Informal document GRSP-62-18
(62nd GRSP, 12-15 December 2017
agenda item 12)

Response to ANEC proposal for Booster phase out in R44

Implemented timeline for phase out of G0/0+/1 w ISOFIX:

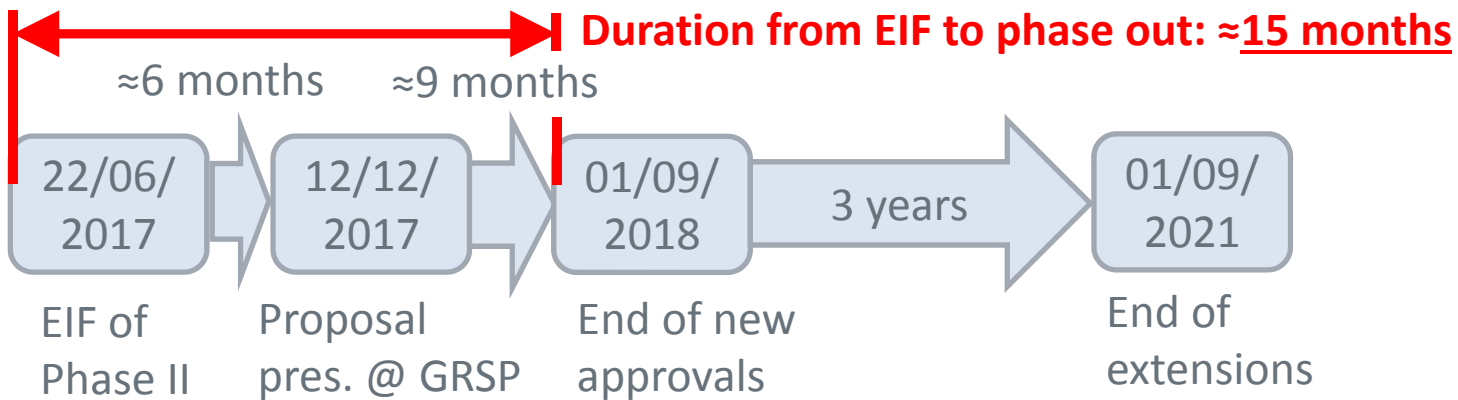
Comparison w timeline of previous phase out

Proposed timeline for phase out of G2 & G2/3 from ANEC:

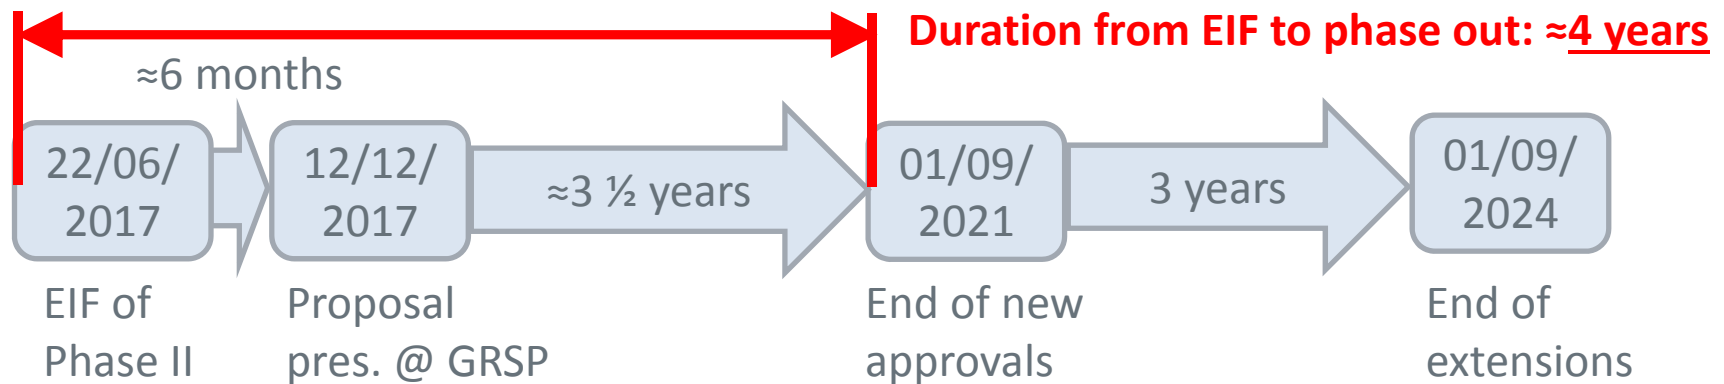
Other reasons why CLEPA thinks the proposed date is to early

- **CLEPA supports the approach to have only one valid CRS standard in force in the future, on which we as CRS industry can focus on, but asks for an adequate time period to implement this transition sensibly.**
- **The development process of new booster seats G2 & G2/3 products already is under progress and the proposed phase out date will make these developments obsolete .**
- **Countries like CN or BR aligned their CRS standards with R44 and need some time to adapt their standards. This concern was already mentioned from CN when the phase out of G0/0+/1 was presented at the 59th GRSP session ([Report, page 9](#))**

Therefore CLEPA believes a similar timeline for the phase out of G2 & G2/3 in R44 as it was implemented for G0/0+/1 would be more sufficient and we propose the following dates:

- **End of new approvals:** **01 September 2021**
- **End of extensions:** **01 September 2024**
